Accepted
Accepted as Noted ✓
Accepted Noted Resubmit
Rejected, Revise Resubmit
Rejected - Unacceptable

STATE OF VERMONT AGENCY OF TRANSPORTAION

MOSCOW ROAD (T.H. NO. 1) OVER MILLER BROOK BRIDGE #3
PROJECT NO. BHO 1446(30)

SHEET 2 OF 5

① TYPICAL 33" X 36" BOX BEAM
SCALE: 1½" = 1'-0"

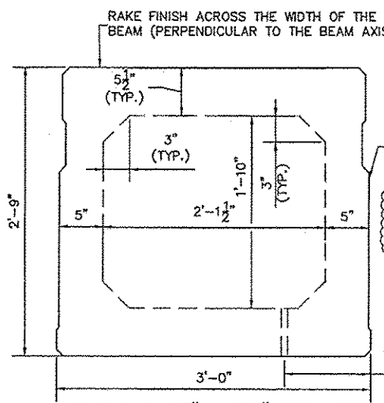
THE TOP, LONGITUDINAL, MILD STEEL SHOULD BE INSIDE THE SHEAR STIRRUPS AS SHOWN ON SHEET 25 OF THE DESIGN PLANS. THIS STEEL CAN ALSO SERVE AS SUPPORT FOR THE SHEAR STIRRUPS INSTEAD OF THE ADDITIONAL PRESTRESSING STRANDS.

THE TOP 2 STRANDS ARE NECESSARY TO SERVE AS SUPPORTS TO FACILITATE THE PLACEMENT OF THE SHEAR STIRRUPS.

THE TOP 2 STRANDS ARE NECESSARY TO SERVE AS SUPPORTS TO FACILITATE THE PLACEMENT OF THE SHEAR STIRRUPS.

② TYPICAL BEAM MIDSPAN SECTION
SCALE: 1½" = 1'-0"

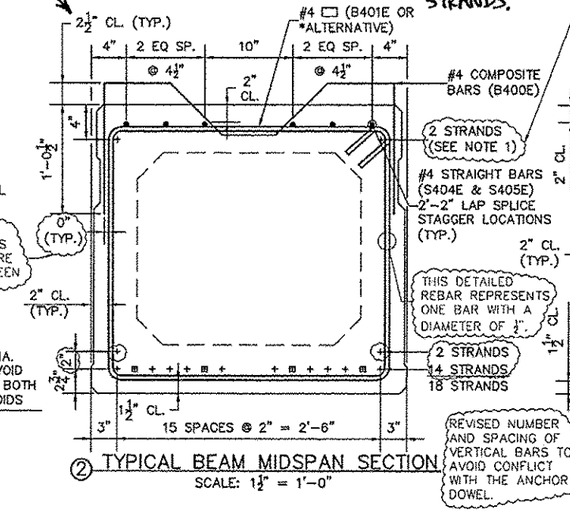
THE PURPOSE OF THIS DIMENSION IS TO INDICATE THERE IS NO GAP BETWEEN THE BARS.

③ TYPICAL END OF BEAM SECTION
SCALE: 1½" = 1'-0"

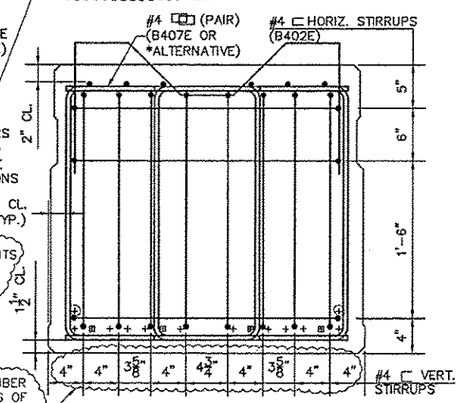
REVISED NUMBER AND SPACING OF VERTICAL BARS TO AVOID CONFLICT WITH THE ANCHOR DOWEL.
